METROPOLITAN GOVERNMENT OF NASHVILLE AND DAVIDSON COUNTY

STAFF RECOMMENDATION
1702 Fourth Avenue North
January 20, 2021

Application: New Construction—Addition and Outbuilding; Partial Demolition
District: Salemtown Neighborhood Conservation Zoning Overlay
Council District: 19
Base Zoning: R6-A
Map and Parcel Number: 08205007100
Applicant: Preston Quirk
Project Lead: Melissa Sajid, Melissa.sajid@nashville.gov

Figure 1. 1702 4th Avenue North.

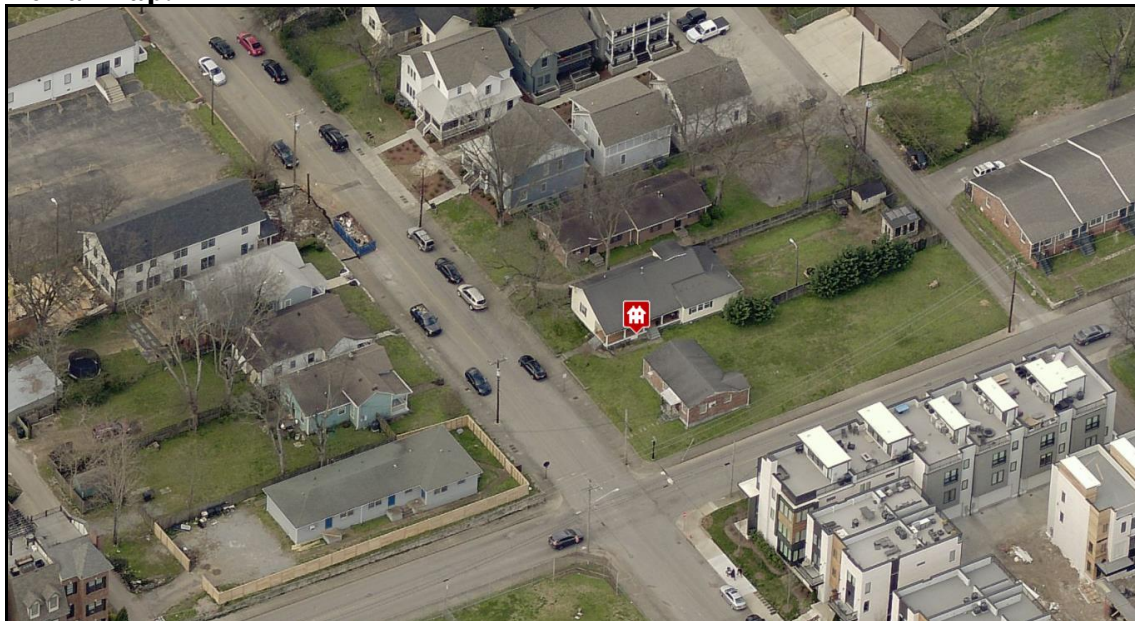
Background: The house located at 1702 4th Avenue North was constructed c. 1888 and contributes to the historic character of the Salemtown neighborhood (Figure 1).

Figure 2. Proposed addition and partial demolition.

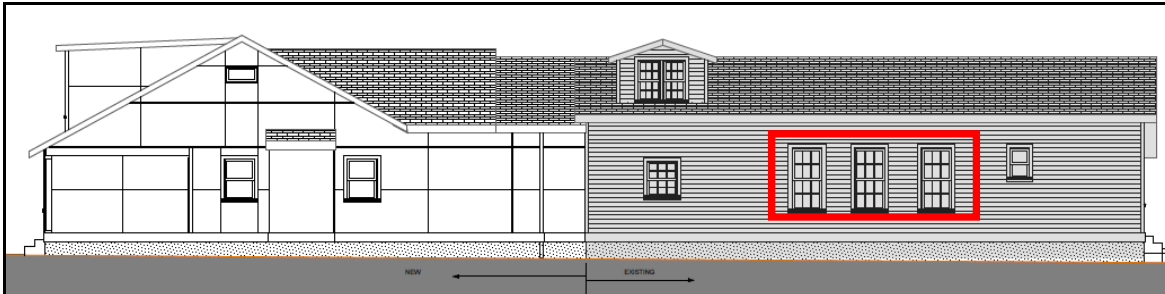
Partial Demolition: The plan includes the demolition of an existing covered porch and alteration of an existing window opening on the left-side façade and the addition of two new window openings (Figures 2 and 3).

Sanborn maps indicate that the right-side and rear of the house have been altered over time. The project does not include any changes to the existing conditions of the side porch, but the covered porch on the rear left is to be removed to allow for the new addition. The porch that is to be removed was likely constructed after 1957 as it is not shown on the 1957 Sanborn map (Figure 4). Staff finds the demolition of the rear porch to be appropriate given its location at the rear, separate roof form, and later date of construction. Staff also finds the proposed window changes to be appropriate as they are located at the midpoint of the historic house, which is consistent with the Commission’s previous decision

Staff therefore finds that the proposed partial demolition meets Section V.B.2 for appropriate demolition and does not meet section V.B.1 for inappropriate demolition.

ELEVATIONS 1

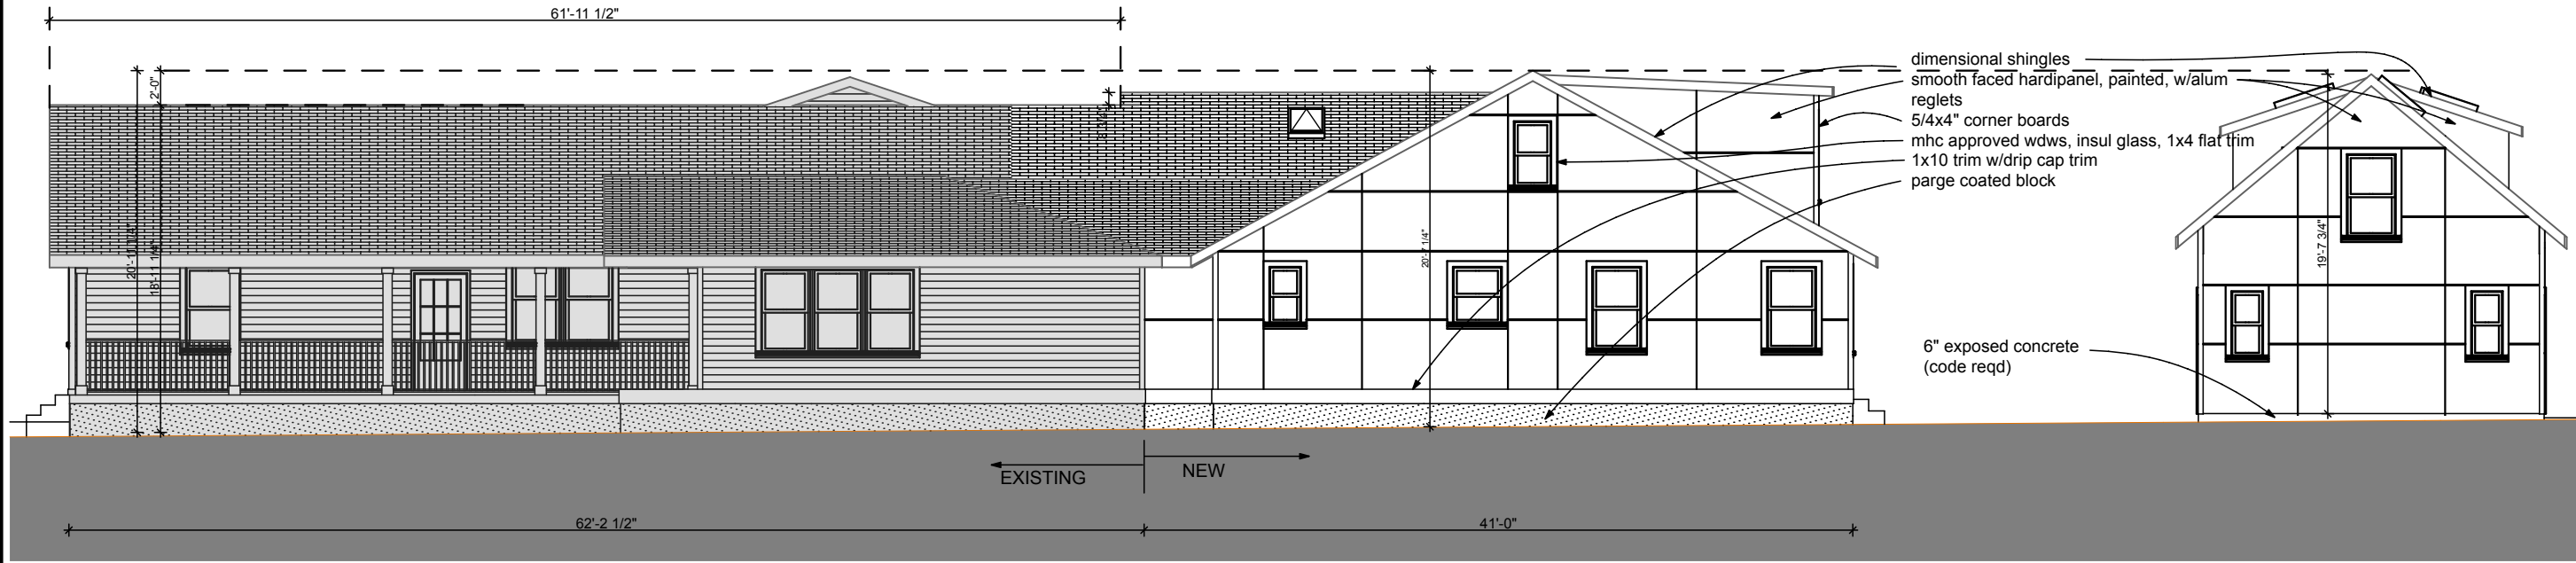
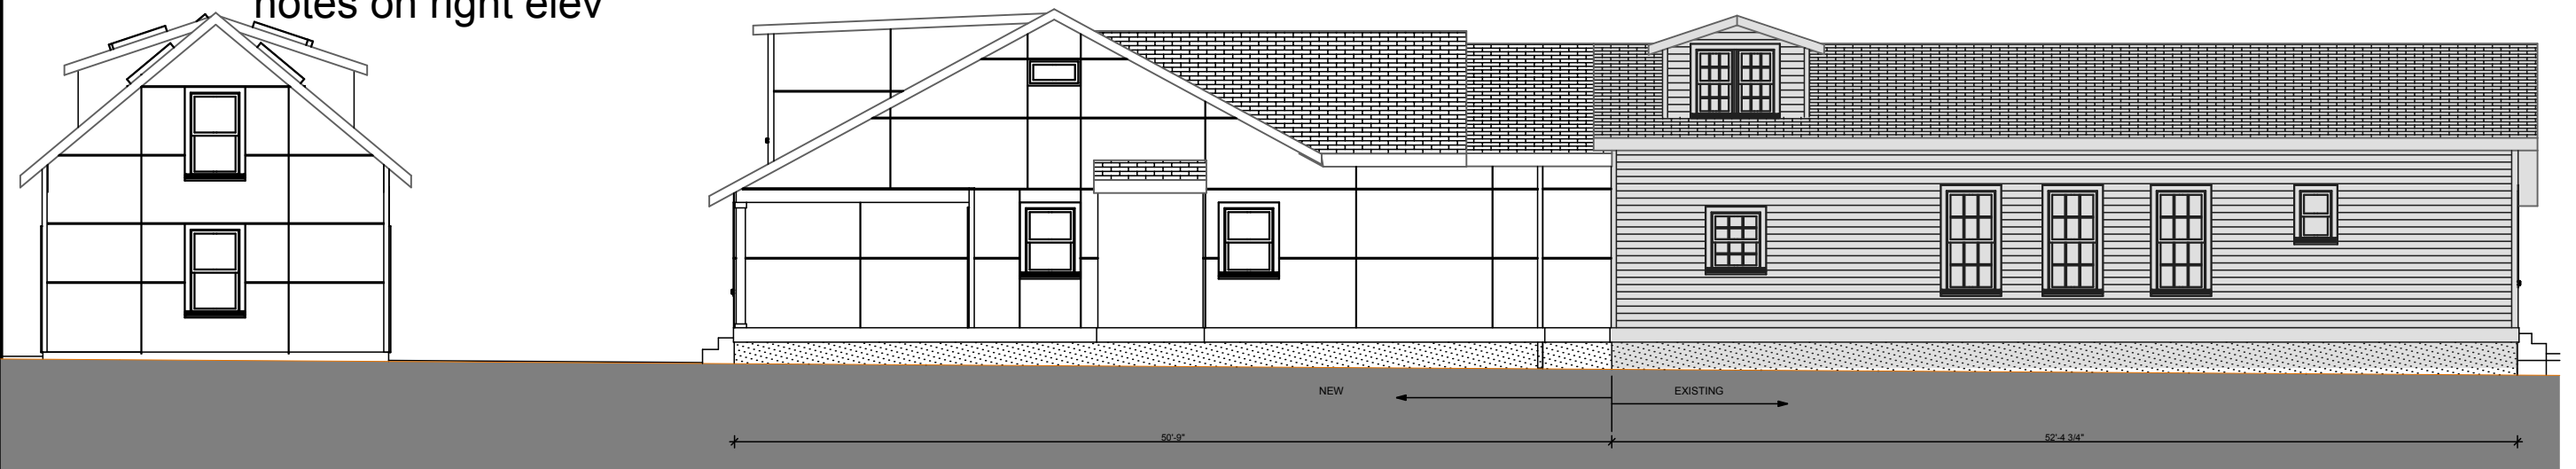
Height & Scale: The request is for a one and one-half story rear addition to a one-story historic house. As proposed, the addition does not extend wider than the historic house and does not more than double the existing footprint. The addition adds a net footprint of approximately one thousand, two hundred, thirteen square feet (1,213 sq. ft.) to the existing (including the porch to be demolished) footprint of approximately one thousand, six hundred, forty-three square feet (1,643 sq. ft.). The addition extends two feet (2') taller than the historic house; the additional height as proposed meets the design guidelines since it occurs more than forty feet (40') beyond the front wall. The eaves of the addition are at the same height or lower than that of the historic house. Staff finds the scale of the addition to be appropriate in this case.

Design, Location & Removability: The location of the addition at the rear of the existing building is in accordance with the design guidelines. The addition is proposed to be inset two feet (2') from both rear corners, which also meets the design guideline that additions should be set in at least one foot (1') per story. The addition goes back four feet (4') on both sides before coming back out to line up with the side walls of the historic house.

The addition is differentiated from the historic house not only by the insets but also by the separate, cross-gabled roof form as well as the more modern cladding materials. These elements help to distinguish it from the historic house and read as an addition. At the same time, its scale, materials, roof form, and fenestration pattern are all compatible with the historic character of the existing house. The addition is designed so that if the addition were to be removed in the future, the historic character of the house would still be intact.

The addition is to be clad in smooth Hardie panels, which have been approved for additions in other conservation overlays. Staff finds that Hardie panels can be appropriate here to help differentiate the addition from the historic house. With the condition that staff approval the materials for the roof color, trim, windows, doors, and rear porch prior to purchase and installation, the project meets Section III.D.

Roof form: The addition has a cross-gabled roof form with pitches of 9/12 and 6.5/12. The project includes a rear dormer on the addition that has a pitch of 0.5/12; staff finds that the shallow pitch of the rear dormer can be appropriate given its location at the rear and since it is set in two feet (2') from the side and rear walls.

Proportion and Rhythm of Openings: The windows on the proposed addition are almost all generally twice as tall as they are wide, thereby meeting the historic proportions of openings. There is one small horizontally oriented window located in the gable field of the addition on the left-side façade. Staff finds that the proposed horizontal window can be appropriate at this location since it is unlikely to be visible from the street. There are no large expanses of wall space without a window or door opening. Staff finds the project's proportion and rhythm of openings to meet Section III.G.

Recommendation: Staff recommends approval of the project with the following conditions:

1. Staff approve the final details, dimensions and materials of the roof color, trim, windows, doors, and rear porch for the addition prior to purchase and installation prior to purchase and installation;
2. Staff approve the final details, dimensions and materials of the roof color, trim, windows, and doors for the outbuilding prior to purchase and installation prior to purchase and installation; and,
3. The HVAC shall be located behind the house or on either side, beyond the mid-point of the house, and utility meters shall be located on the side of the building, within 5' of the front corner. Alternative mechanical and utility locations must be approved prior to an administrative sign-off on building permit(s).
